Re: 2021/5750/P– 8A HAMPSTEAD HILL GARDENS, LONDON, NW3 2PL

Further to the submission of the above planning application, and following your consultation exercise, we remain committed to working with the community in order to ensure our submission allows a thorough and proper assessment of the proposed development to be made. Therefore, this letter has been prepared in order to avoid any confusion and offer clarity on our submission.

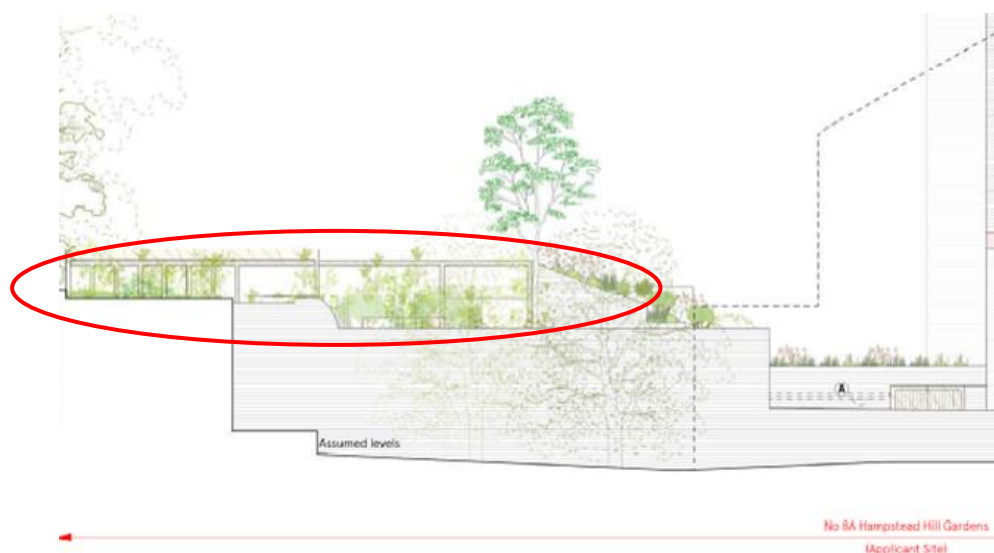
The baseline condition of the existing site is that of an existing concrete garage with surrounding hardstanding which is in poor condition and is unsympathetic to the site and surrounding area. The lower ground floor windows of 8 Hampstead Hill Gardens currently look out onto a solid concrete wall which is in poor condition. Please refer to the photograph at the top of page 3.

The proposed development will result in a net gain of landscaping, planting and garden area which is a vast improvement to the existing site and the proposed development will enhance the character and appearance of the site and surrounding area, as well as improve neighbour amenity.

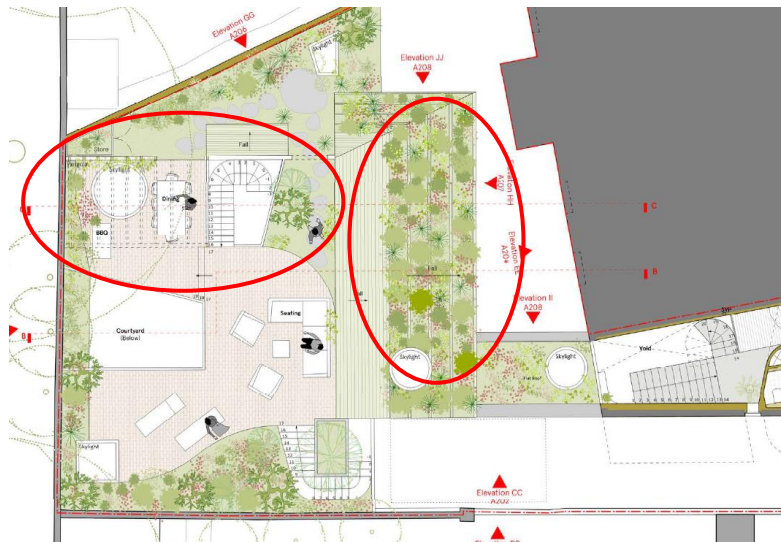
Objection letters consider that the raised height of the garage terrace and the boundary wall/partition will result in an overbearing impact/overlooking to neighbours. The neighbour at 10 Hampstead Hill Gardens has raised specific concerns to submitted drawing number 288-A203, whilst other concerns have queried the height of the existing garage/proposed new terrace level.

Firstly, it should be identified that the neighbour from no.10 seems to have misinterpreted drawing number 288-A203. They have mistakenly considered the pergola structure and stepped planted terrace to represent an increase in the height of the side boundaries to the terrace. This is not the case. The extracts below (taken from drawing numbers 288-A203 and 288-A102 and outlined in red) shows the planted terrace is stepped in from neighbouring boundaries and that the pergola, which is an open lightweight structure and which is stepped in from two of the three boundaries, would not be visually overbearing to neighbours. The proposed development will therefore not result in an increase in boundary wall height.
